NORTHEAST UTILITIES

December 23, 1991

Re: Employee Concerns

Millstone Nuclear Power Station, Unit No. 2
RI-91-A-0231

Figure 1

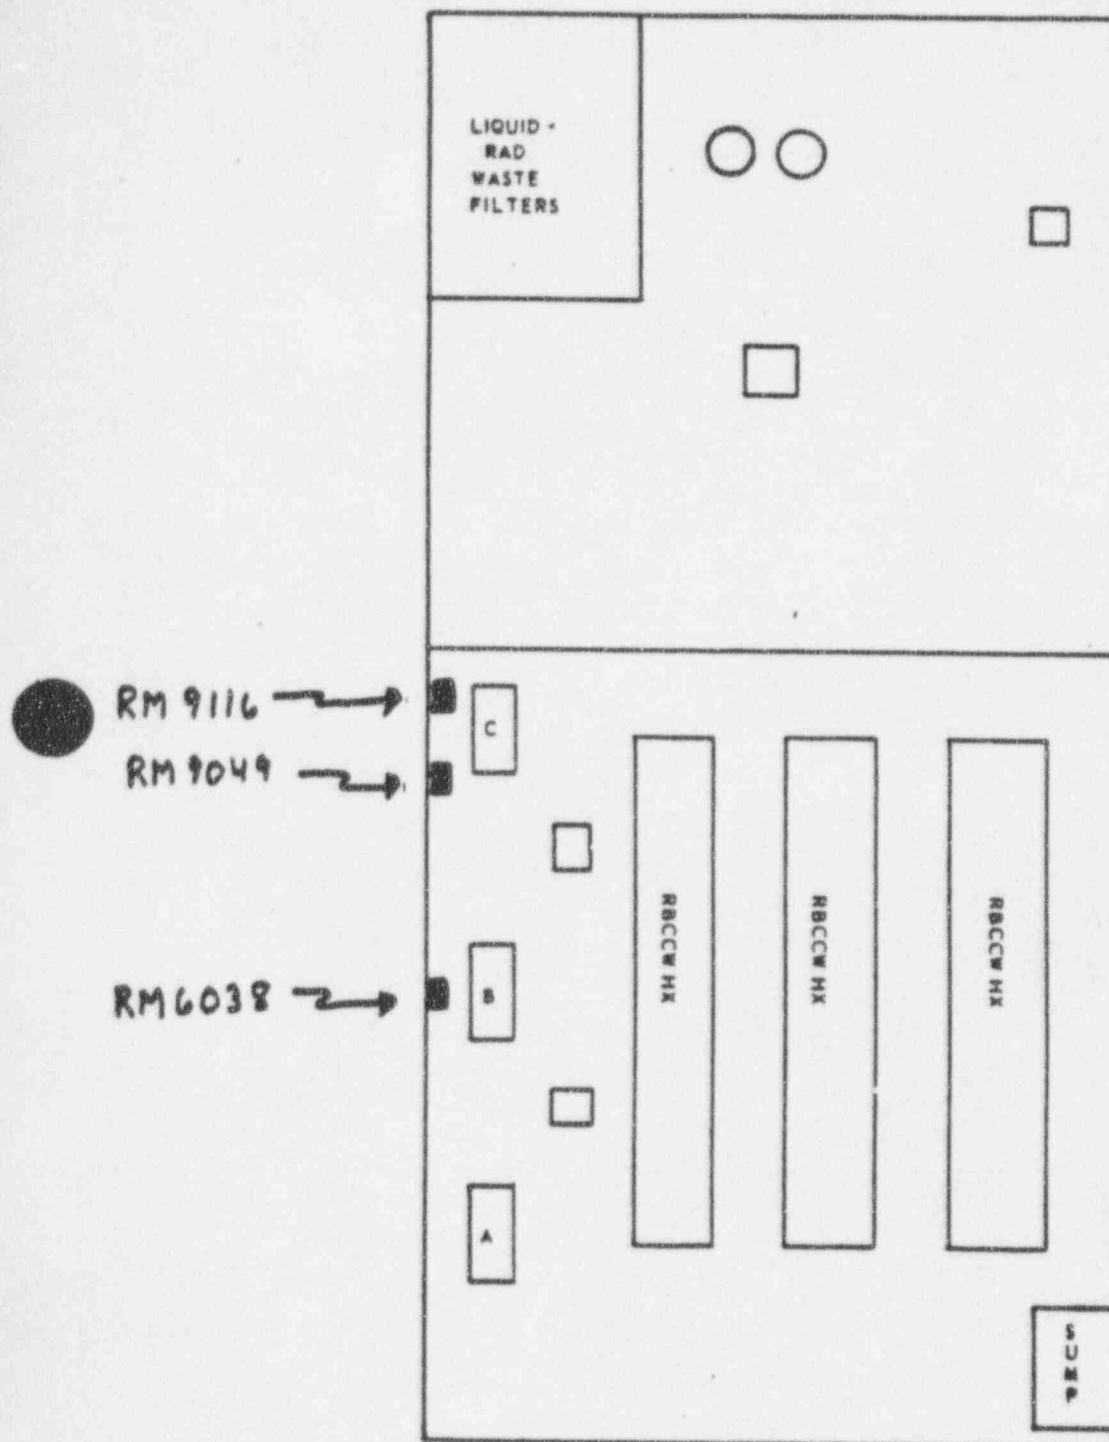
The RBCCW radiation monitor (RM 6083) sample valves are not labeled. Additionally, the piping and instrumentation drawing (P&ID) 25203-26022, Sheet No. 1, does not reflect the actual installed configuration of the sample lines. (This concern is similar to issue 210-1 referred to you by letter under File Number RI-91-A-0210, dated August 22, 1991.)

Please discuss the validity of this assertion. Please provide assurances that the RBCCW radiation monitor (RM 6083) sample valves will be labeled in the future and that piping and instrumentation drawings will reflect actual conditions.

With respect to the P&ID sheet, this assertion is a true statement but does not represent a valid safety concern. The drawing at issue has been checked against actual system and the installed configuration of the sample lines was correct. However, a difference was found in that the lead brick shielding, which was removed when the monitor was upgraded to a unit not requiring additional shielding, is still shown on the drawing. A drawing change has been issued to eliminate the lead bricks shown on the P&ID.
